RE: Parkwood Terrace (Church Subdivision)
13457 NE 205th St, Woodinville WA 98072
PPA14001, SEP14017
Blueline Job No. 14-175

This letter is in response to your review of the Parkwood Terrace (Church Subdivision) Project dated April 22, 2015. The plans have been revised per your requested revisions. Below is a list of each comment with our responses in bold.

RE: Parkwood Terrace (Church Subdivision)
13457 NE 205th St, Woodinville WA 98072
PPA14001, SEP14017
Blueline Job No. 14-175

This letter is in response to your review of the Parkwood Terrace (Church Subdivision) Project dated April 1, 2015. The plans have been revised per your requested revisions. Below is a list of each comment with our responses in bold.

FIGURE 1

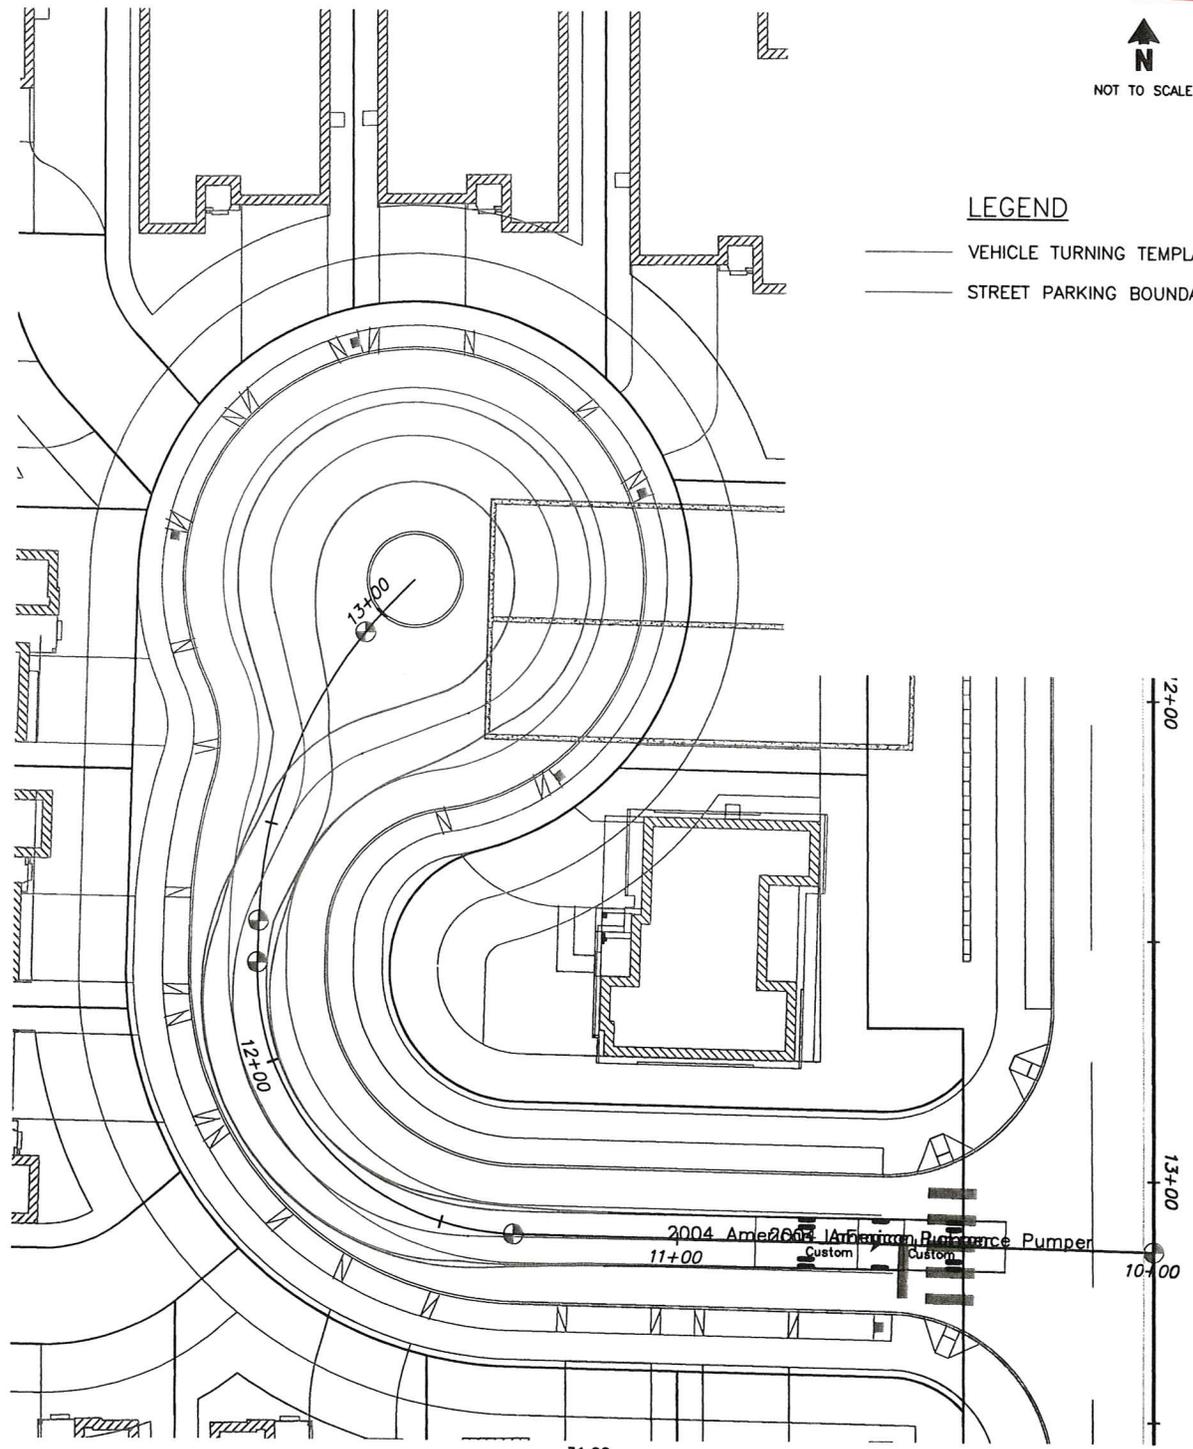
2. Please submit a supplemental plan showing an SU Design Vehicle as well as the firetruck hook & ladder turning through the plat road. Please also label the plat road and cul-de-sac radii. The City is concerned with the radius being too tight and may require this to be increased depending on the turning exhibits. **The transportation engineer completed the auto-turn analysis using the largest vehicle specs that were provided from the city (see attached exhibit). Based on this auto-turn exhibit as well as the proposed driveway locations, roadway widths and curb radii, we will be proposing no parking on the west and south side of the internal plat roadway along with the entire perimeter of the cul-de-sac.**
